SERVICE BULLETIN

M-1010

SAFETY RECALL 073 ADDENDUM XLH - FXR FRONT BRAKE CALIPER UPPER MOUNTING BOLT RETURN OF UNUSED PARTS FROM DEALER STOCK

Front Brake Caliper Upper Mounting Bolt - Identification by Number of Rows of Knurls on Bolt Head

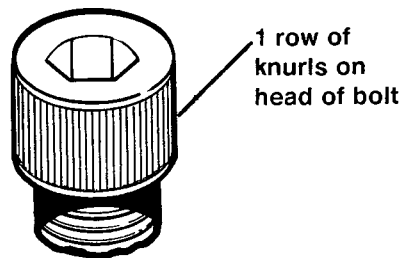
Any remaining dealer stock of H-D Part No. 855 (front brake caliper upper mounting bolts) must not be installed in motorcycles for the reasons detailed in Service Bulletin M-1004 (Safety Recall 073), dated November 6, 1990. These particular bolts have been replaced by H-D Part No. 855A mounting bolts.

Bolt (Part No. 855) and bolt (Part No. 855A) may be distinguished from each other by the number of rows of knurls on the head of each respective bolt. See illustration. **Bolt (Part No. 855) has two rows of knurls on its head. New replacement bolt (Part No. 855A) has one row of knurls on its head.**

BOLT (Part No. 855)
(return to Harley-Davidson, Inc. for credit)

**NEW REPLACEMENT BOLT
(Part No. 855A)**
